RAILROAD COMMISSION OF TEXAS

RE: Monticello-Thermo Mine, Permit No. 5G
Revision No. 34
H-Area Reclamation Plan

Monticello-Thermo Mine, Permit No. 5G
Revision No. 34
Proposed H-Area Reclamation Plan
Concerns Rendering the Application ~~Incomplete~~ or Deficient
September 21, 2018 (originally noted on January 19, 2018)

List B. Concerns that Appear to Render the Application Deficient

ATTACHMENT B

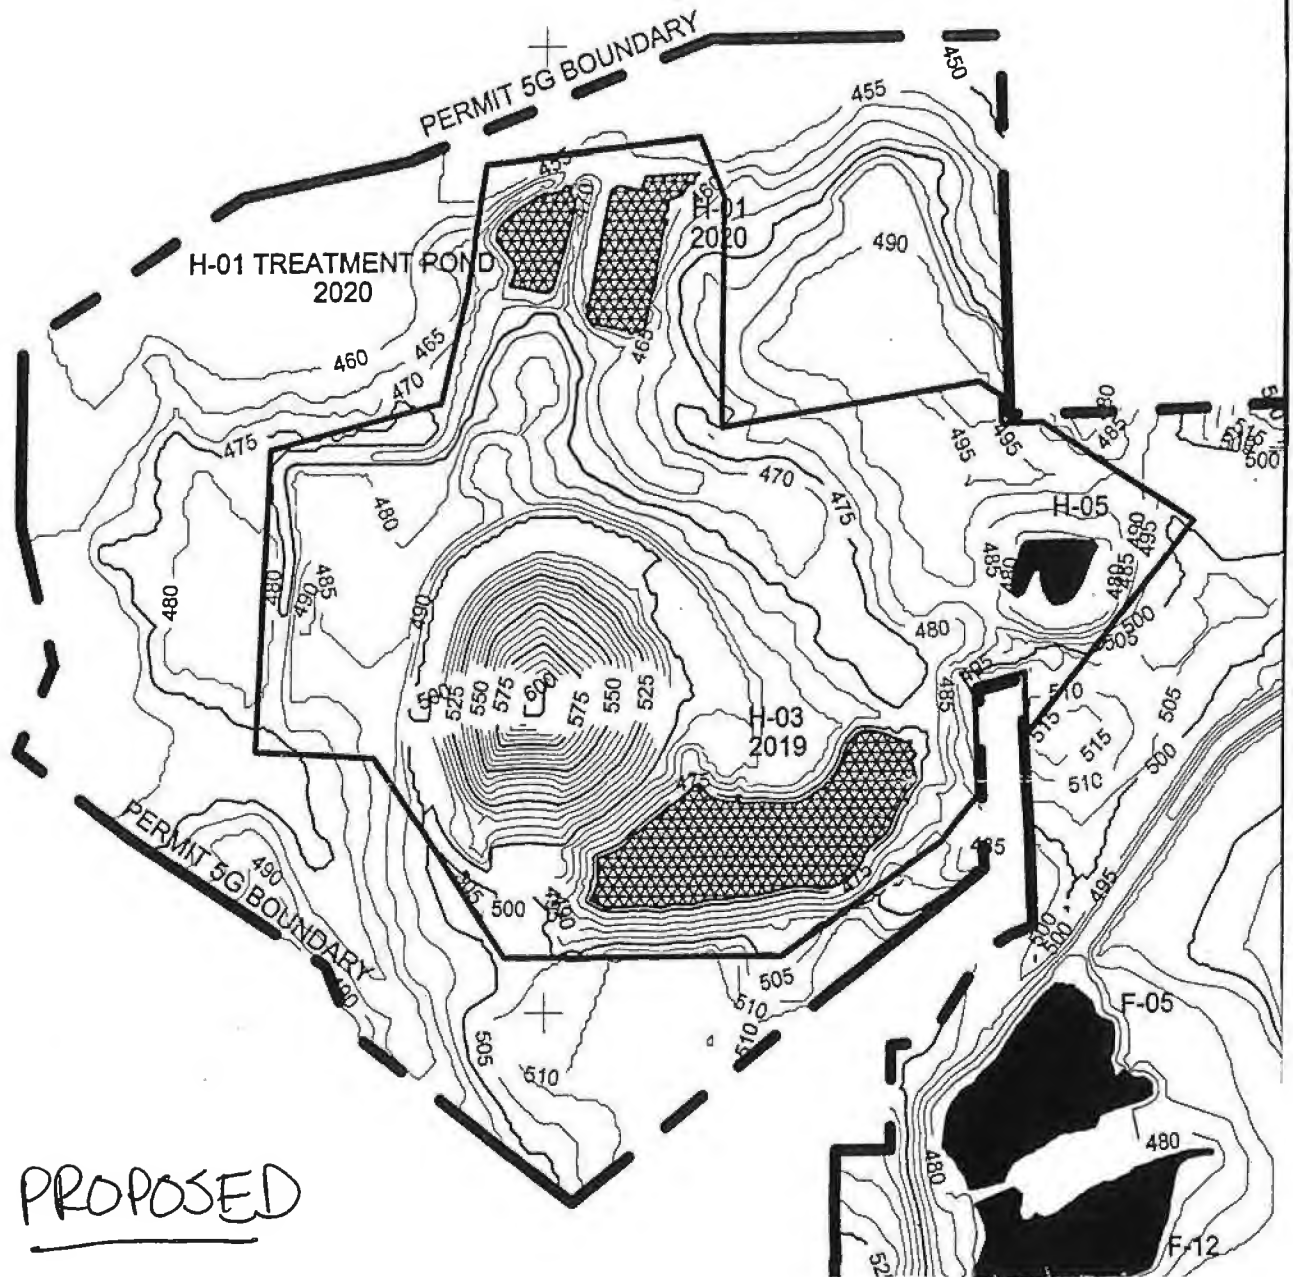
Revision 34 primarily seeks to change (increase) post mine slopes for 75 acres in the H area from what was approved in Revision 30. Attachment A is a figure showing currently approved slopes in the H area; attachment B shows the proposed slopes. Two key elements of the revision application include leaving an unsuitable material stockpile in place and covering it with four feet of topsoil to build a hill, rather than using the stockpile to fill in the final mine pit, and leaving the final mine pit in its current configuration as a water body instead of filling it in and sloping is as shown in Attachment A.

FIGURE E-1
THERMO MINE
H-AREA RECLAMATION PLAN
LUMINANT MINING COMPANY LLC

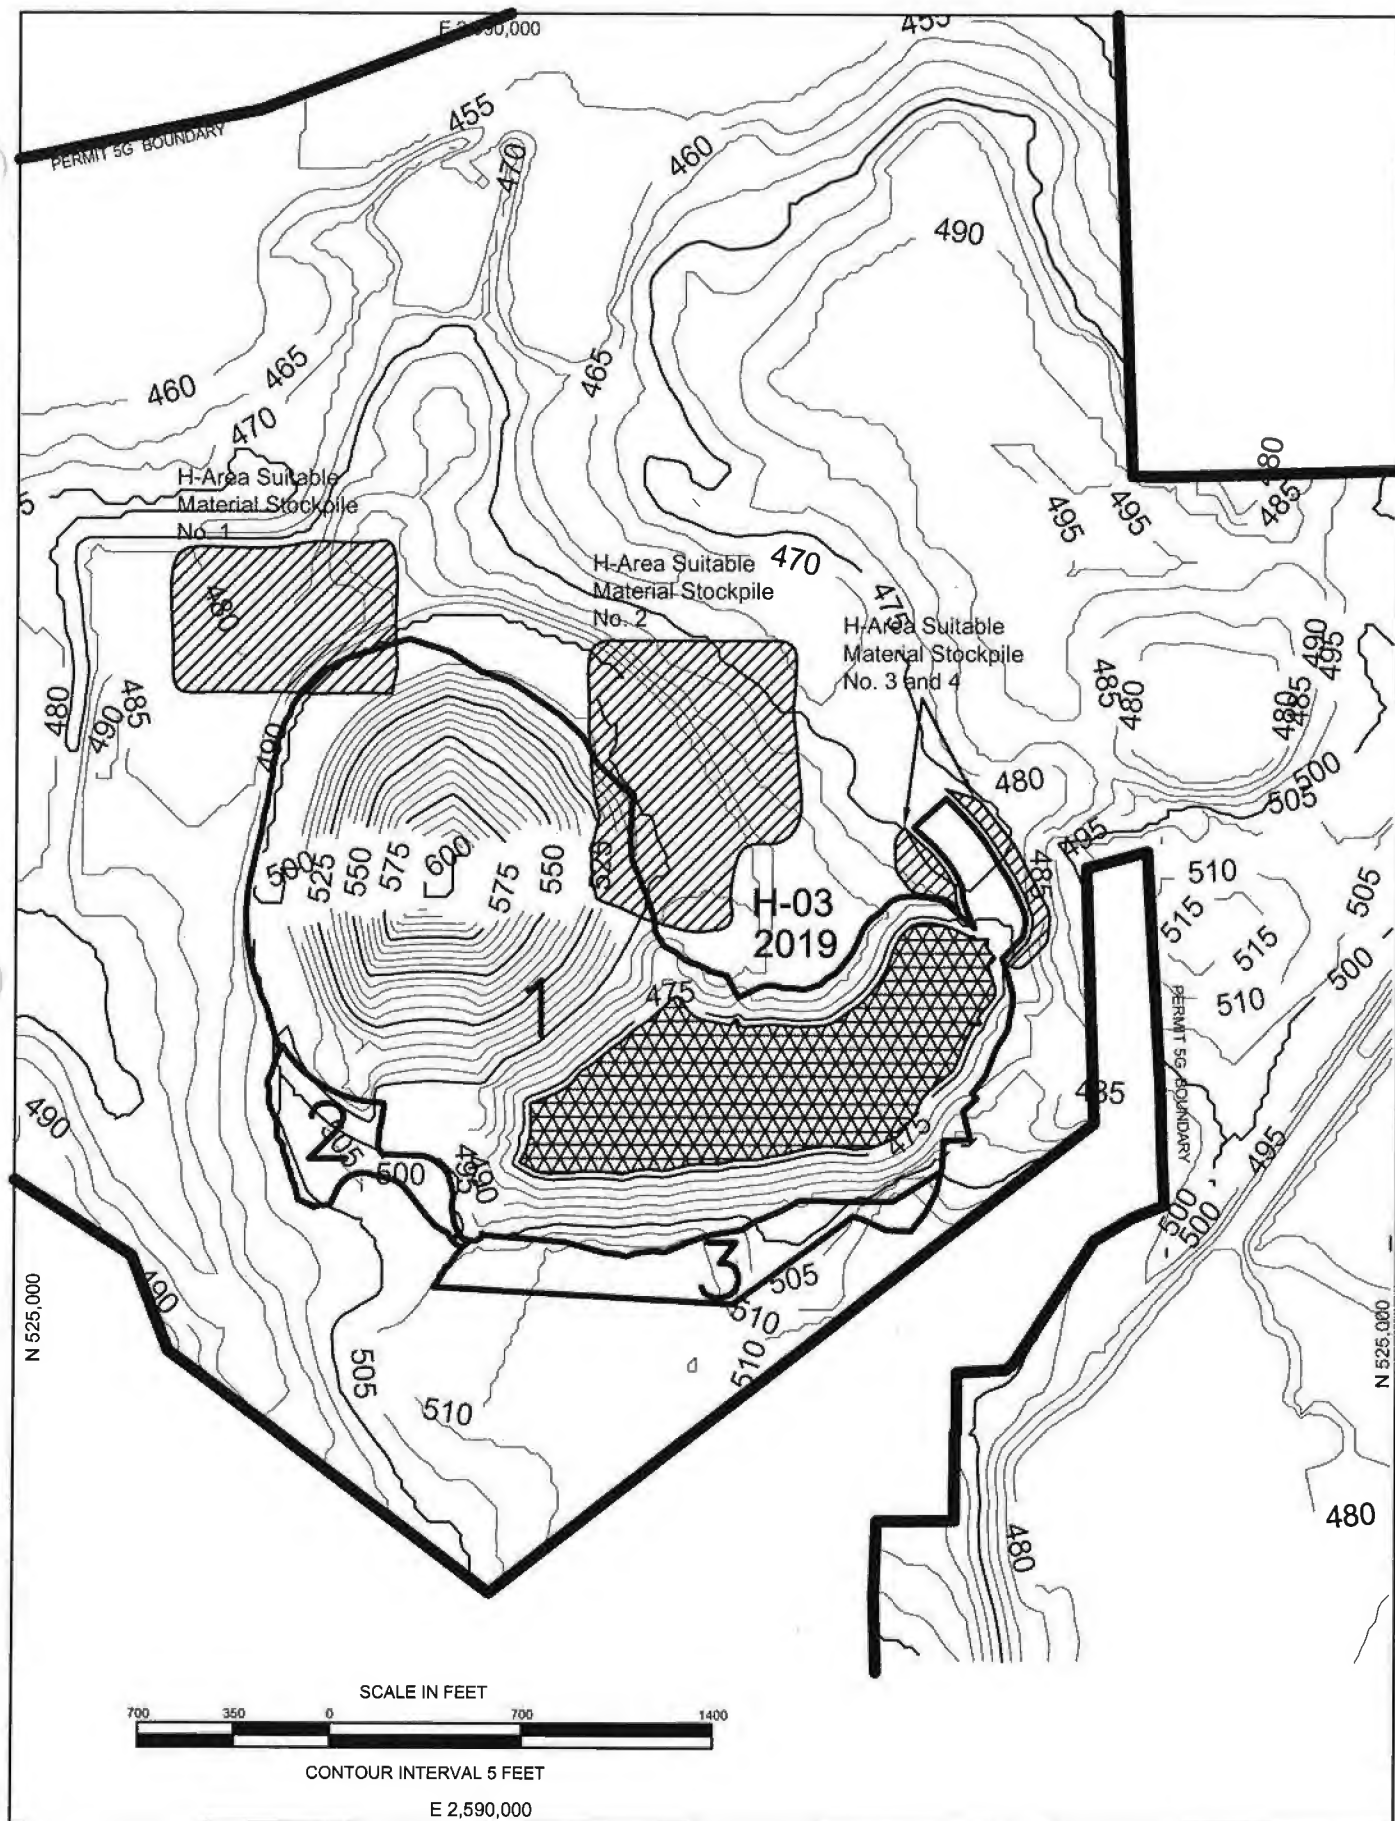
- B-12. §12.139 Luminant classifies the material that will remain in Zone 2 and in Zone 3 as “*Suitable Material*” in an affected area that was not mined during progression of the active pit. Luminant provided no details regarding the potential ripping and dinking of Zone 2 and Zone 3 following suitable material removal, nor what it plans to do with the excess stockpile material. Staff considers that Luminant’s proposed ripping and dinking plan must be no less intensive than that approved for the Oak Hill Mine, Permit No. 46C, Revision No. 40.

- B-14. §12.139 Luminant indicates in Appendix E that mobile equipment will move approximately 750,000 cubic yards of subgrade material from Zone 1; however, it is not clear where the material will be placed. Additionally, an explanation has not been provided to justify the proposed start date of the activities proposed in the reclamation plan.
